# ROCKY FORK - BLACKCLICK ACCORD IMPLEMENTATION PANEL

**Z05-079: 6490 Harlem Rd - Amendment**

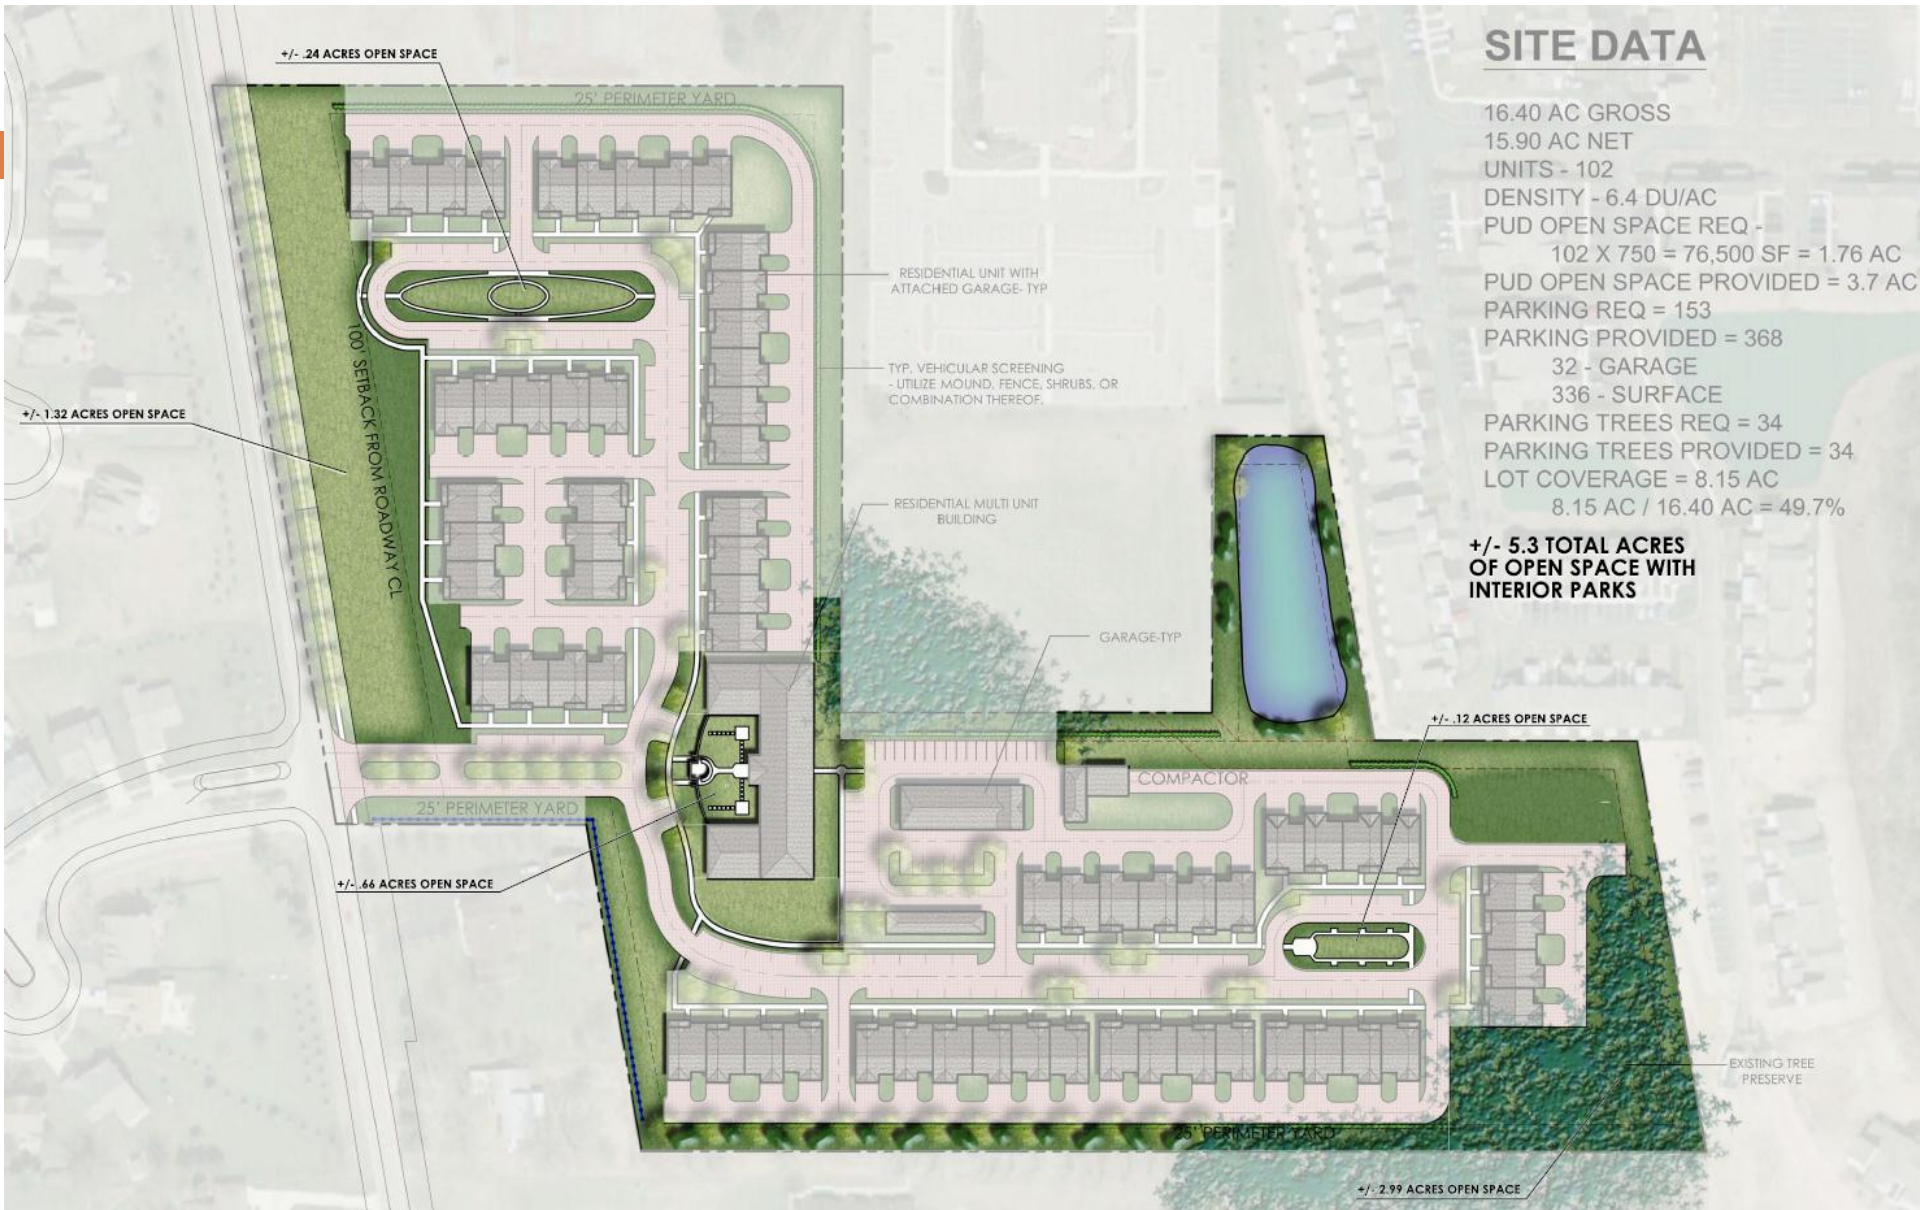
- RFBA Comments 3/18/2010
  - Snow fences around existing tree cover in central open space and southwest open space.
  - All buildings will be two stories.
  - Fenestration on all four sides.
  - The primary building material will be brick for building façades facing Harlem Rd including southern most building.
  - Special consideration to landscaping and buffering will be given to southwest corner for headlight shielding.

- Staff Comments
  - Density remains unchanged.
  - 3-story building at the center of the site is reasonable.
  - Staff encourages maximum protection of existing trees in the southeast corner of the site.
  - Staff stresses, that as depicted on the site plan, there should be no water detention in the open space north of the tree stand in the southeast corner.

Building Rendering

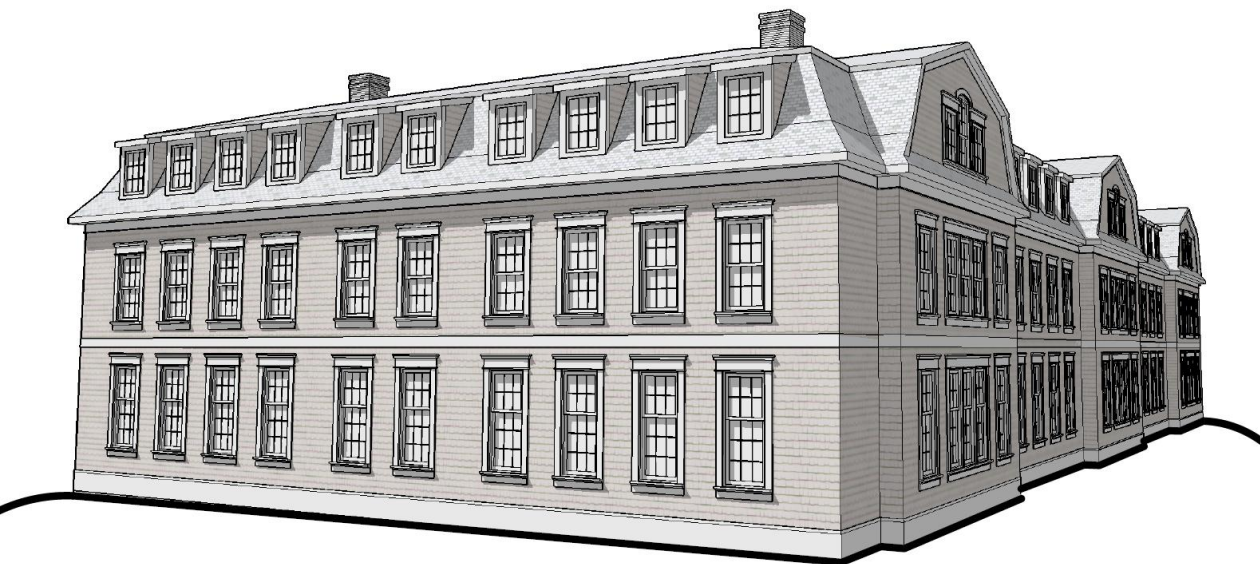
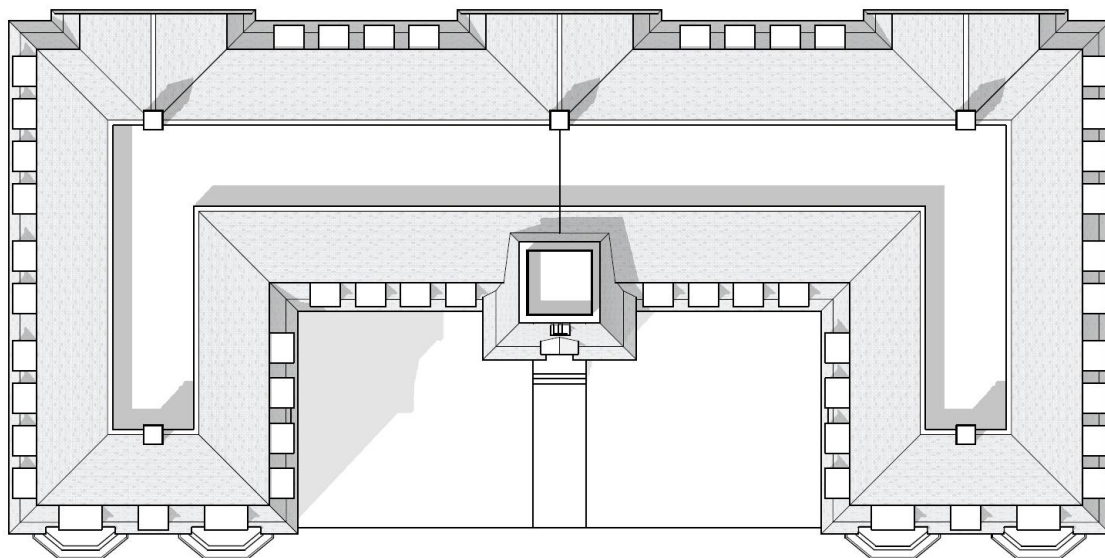
- Revisions to Text and New Renderings
  - Reconfiguration to the location of open space, while maintaining same amount of space.
  - Building height text change: Buildings shall not be less than one and half stories and not more than ~~two~~ three stories in appearance as depicted in the attached conceptual rendering.
  - Building elevations for attached single family units.
